FIELD INSPECTION REPORT

Project Name:	Mountain Valley Pipeline	Inspector:	Matthew Grant
Inspection Date:	Wednesday, September 8, 2021	Project Contact:	Brian Clauto
Spread G: Craig	St 11353-11471	Weather:	Dry

Figure 1: P1 is down and torn at near St 11451.

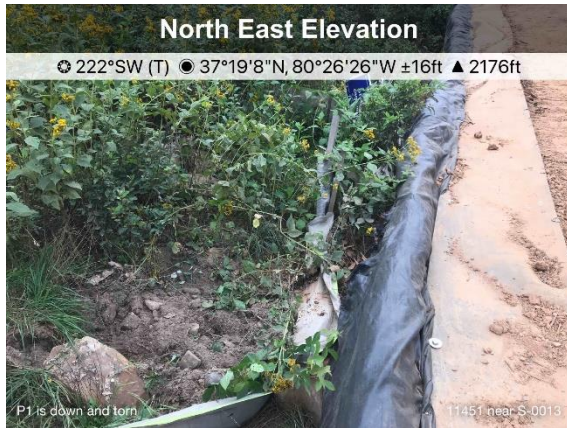
- St 11451 P1 is down and torn
- St 11444- 11445 areas of rill erosion and lacks stabilization

Recommended Corrective Action: Maintain and install all controls per the approved PSS&S.
